**Historical Architectural Review Board
COA Final Review Sheet**

HDC-2023-00033

Address: 941 W. Turner Street

Proposal: Convert enclosed porch to open porch

**The enclosed porch at 941 W. Turner Street.
(Applicant)**

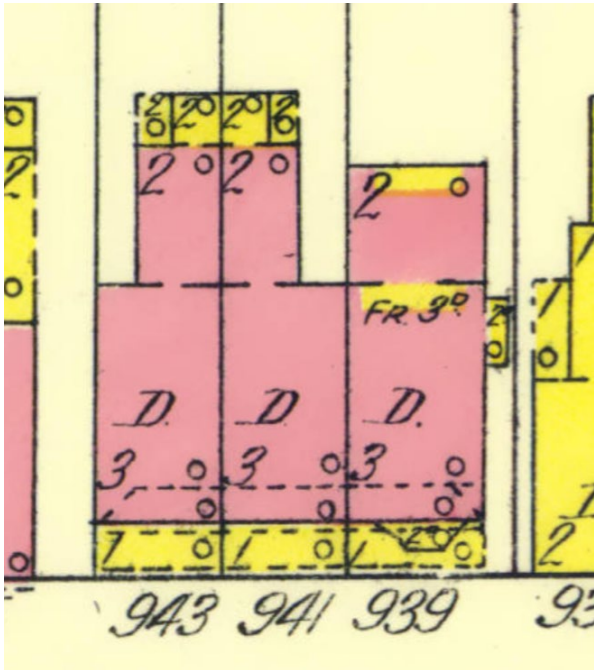
This application proposes to demolish the existing enclosed porch at 941 W. Turner Street and install new columns, railings, and balusters that would approximate the porch's assumed original appearance. The application provides a photograph of porch railings and columns, but does not include a demolition plan, photos of the existing façade wall to be exposed, or details of each element to be installed.

Staff finds that the existing enclosed porch has lost enough integrity that it no longer holds historical significance and supports the conversion of the porch to its original open configuration. However, staff finds that the application lacks the information necessary to understand the scope of work. Staff requests the following: a demolition plan showing all elements to be removed; photos of the existing masonry façade wall, windows, and door that will be exposed following the porch removal; specs on flooring, roofing, balusters and railings, posts, brackets, and any other elements to be installed; dimensions on the submitted plan; and a scaled section drawing showing the existing façade and proposed porch.

Ms. Keller noted that the applicant provided further details on the railings, porch columns, and door several hours before the meeting. She stated that the staff's recommendation for denial was based on the incomplete application, adding that staff supports reopening the porch, provided enough details are supplied by the applicant. She commented that she still has questions about the extent of demolition.

Mr. Driscoll clarified that the existing porch roof would remain in place, as well as the ceiling and masonry wall that would be exposed. The HARB observed that the wall is currently painted gray and suggested painting it a brick color once it is exposed. Mr. Driscoll explained that he plans to install a flat wood railing system and wood floorboards on the porch floor.

Mr. Huber moved to approve the application presented on 6/5/2023 for the opening of the enclosed porch at 941 W. Turner Street, with the staff to review details, pursuant to Chapter 3, Section 3.7 Porches & Steps, with the provision that the applicant may also replace the porch flooring with wood tongue and groove flooring. Mr. Hart seconded the motion, which carried with unanimous support.
